# CITY OF SACRAMENTO

- SUBJECT:
1. Environmental Determination
  2. Tentative Map (P85-454)

LOCATION: West side of Franklin Boulevard, 500+<sup>1</sup> north of Mack Road.

The applicant is requesting a tentative map to develop 172 airspace condominiums. The Planning Commission and staff recommend approval of the request with conditions.

SITE PLAN  
SITE A - PHASE 1

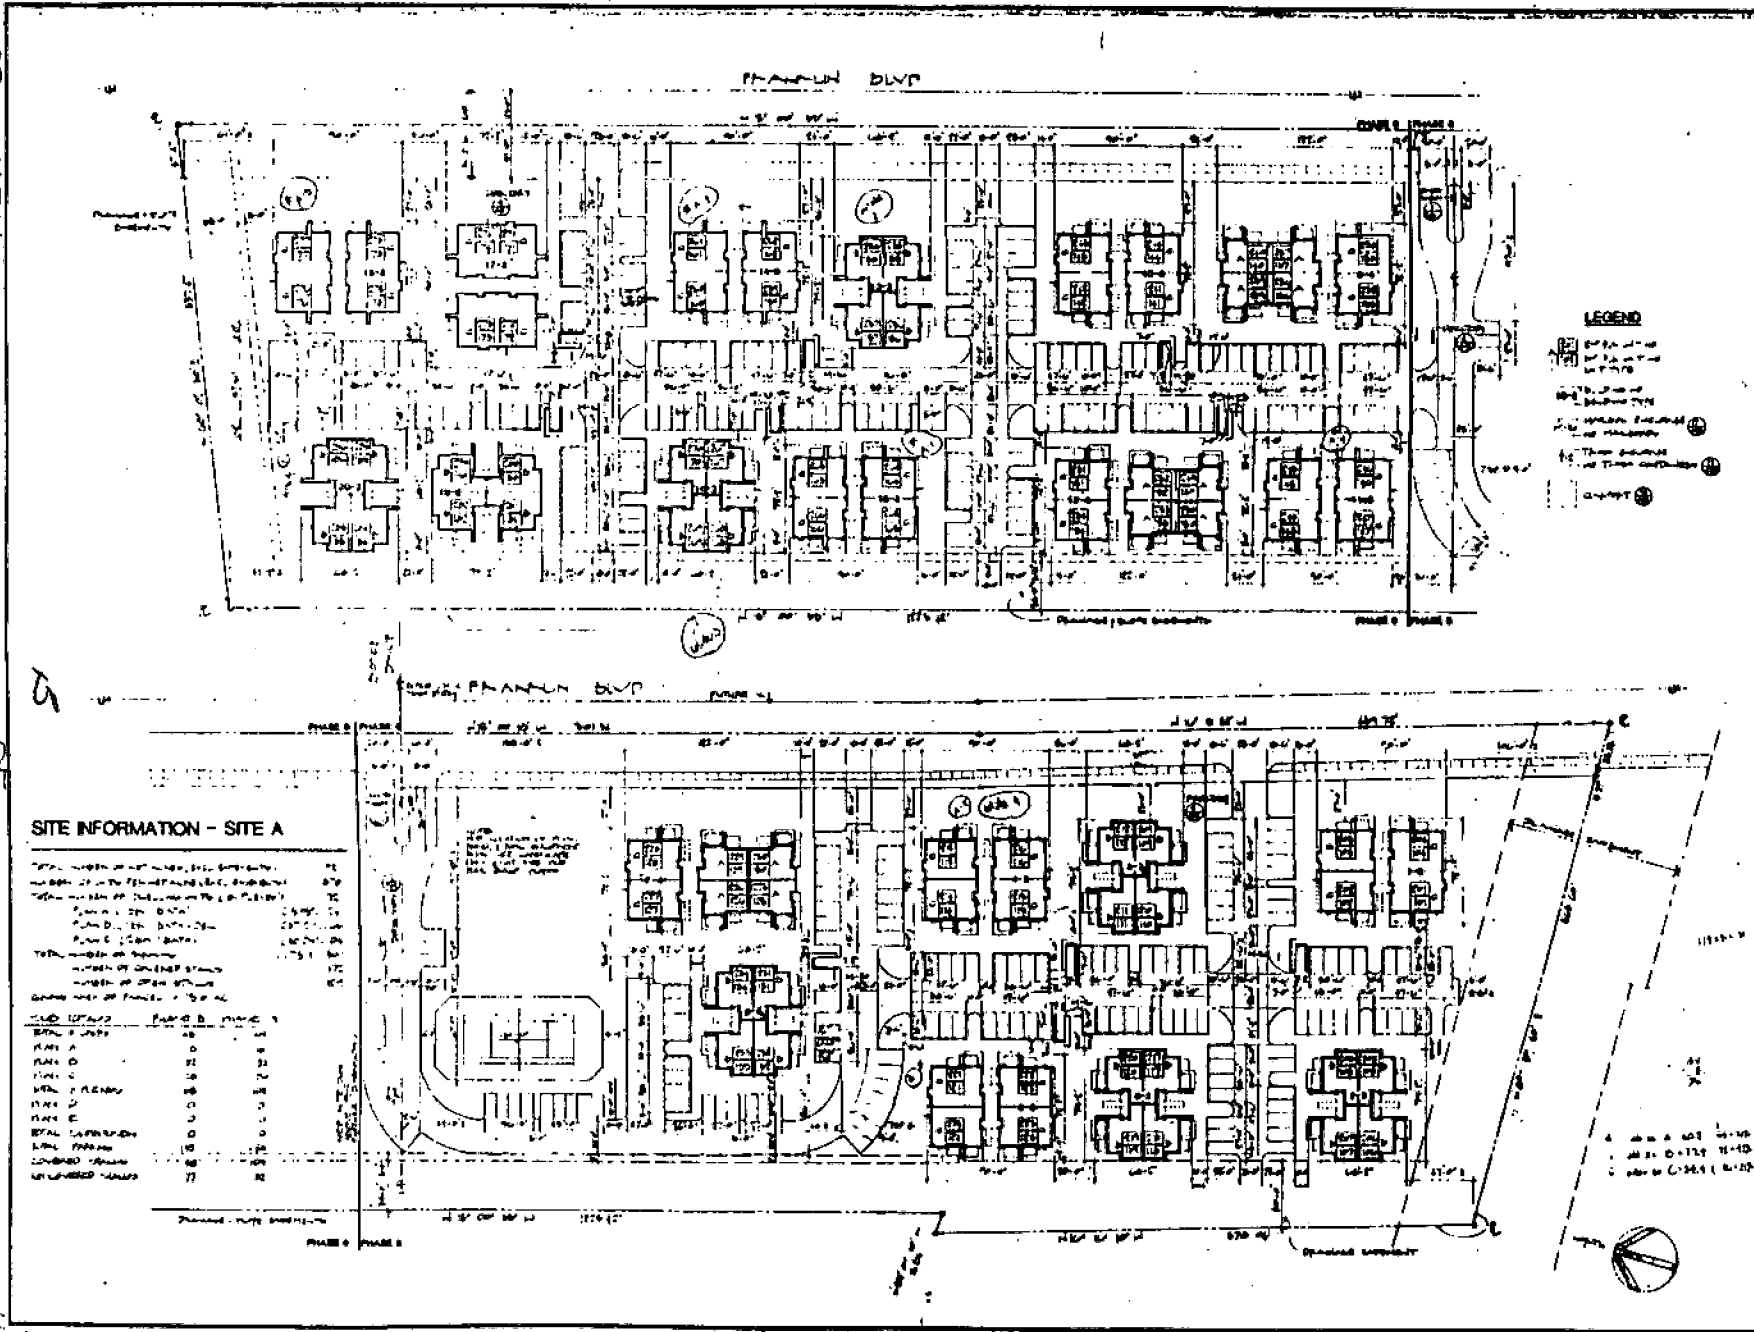
The submitted site plan indicates a 30 foot building setback from the Franklin Boulevard right-of-way. Staff recommends that this area be landscaped with a variety of trees and shrubs and minimum four foot high undulating berms. Walkways crossing this landscaped area from Franklin Boulevard to the condominium units should be prohibited to prevent parking along Franklin Boulevard.

The site is surrounded on the remaining three sites by a drainage canal. Staff recommends that large evergreen trees should be planted adjacent to the north, south and west property lines in order to screen the canal from the condominium units.

Trash enclosure facilities and bicycle parking areas have not been indicated on the submitted site plan. A swimming pool and pond are indicated but not shown on the site plan. The location of these facilities should be shown on the revised site plan subject to Planning Director review and approval.

The Traffic Engineering Division has reviewed the submitted site plan and requires the three driveway entrances to be 35 feet wide. The center divider of the main driveway shall be prohibited from being located within 50 feet of the Franklin Boulevard property line. Traffic Engineering has also required as a tentative map condition for the developer to construct a traffic signal at the intersection of the project driveway, Boyce Drive and Franklin Boulevard in order to assist in regulating traffic flow. This requirement is due to the increase in trip generations resulting from the construction of the project.

The site plan indicates 172 covered and 129 uncovered parking spaces for a total of 301 spaces. These spaces will meet the 1:1.5 parking ratio recommended for multiple family developments.

In revising the submitted site plan the applicant should conform to the guidelines of the attached Multiple Family Residential Design Criteria (Exhibit D).

- 1. Revised landscaped, shading and irrigation plans shall be submitted for staff review and approval prior to issuance of building permits. The revised plans shall indicate minimum four foot high undulating berms in the landscaped setback adjacent to Franklin Boulevard and large evergreen trees adjacent to the north, south and west property lines. Walkway crossing the landscaped area from Franklin Boulevard to the condominium units are prohibited.
- 2. The applicant shall prepare a revised site plan and elevations indicating the location and type of trash enclosure facilities, recreational amenities and bicycle parking facilities, subject to Planning Director review and approval prior to issuance of building permits.
- 3. The revised site plan shall meet the requirements of the Traffic Engineering Division.

4. All roofs shall be covered with wood shake, shingle, tile material or heavy butt composition shingle that is approved by the Planning Director.
5. The project shall conform to the attached Multiple Family Residential Design Criteria (Exhibit D).

EXHIBIT C

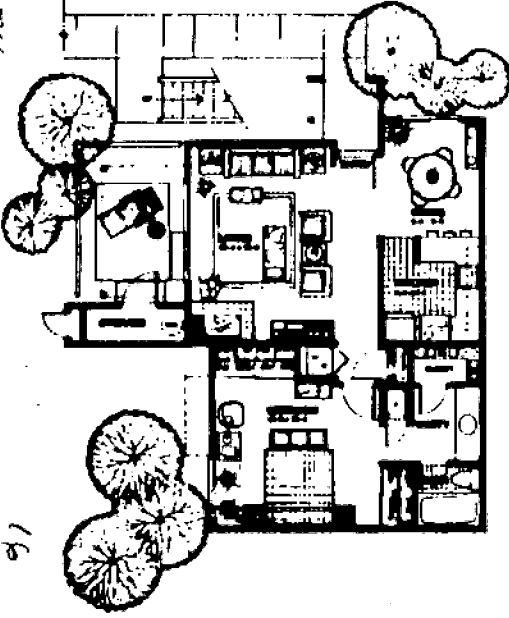
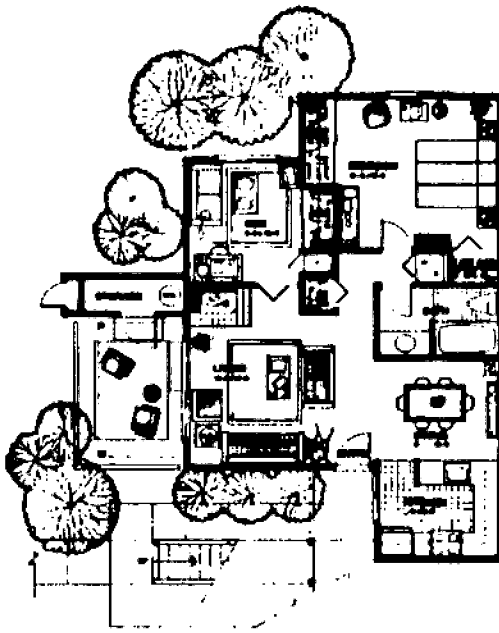
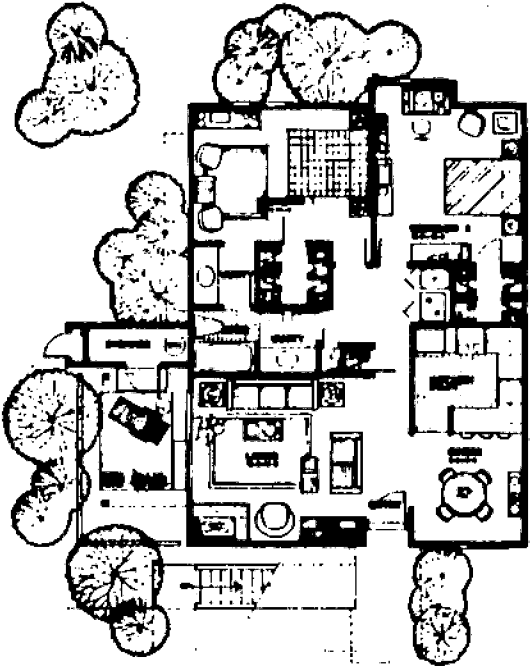
The applicant proposes to construct the condominium structures utilizing horizontal wood siding and stucco. Staircase railings and patio and balconies

are also proposed to use wood exteriors. Staff notes that the buildings are attractively designed and will be compatible with adjacent residential uses. Staff recommends that a wood shake roofing material be used, subject to Planning Director review and approval. The applicant should also be aware that the height limit in the Garden Apartment zone is 35 feet. The elevations should reflect this height requirement.

Specific plans have not been submitted for carports, trash enclosure facilities, recreational facilities nor bicycle enclosure facilities. Specific elevations and locations for these facilities shall be submitted for the review and approval of the Planning Director prior to issuance of building permits. The applicant should use the guidelines outlined in the Multiple Family Residential Design Criteria when designing these facilities (Exhibit D).
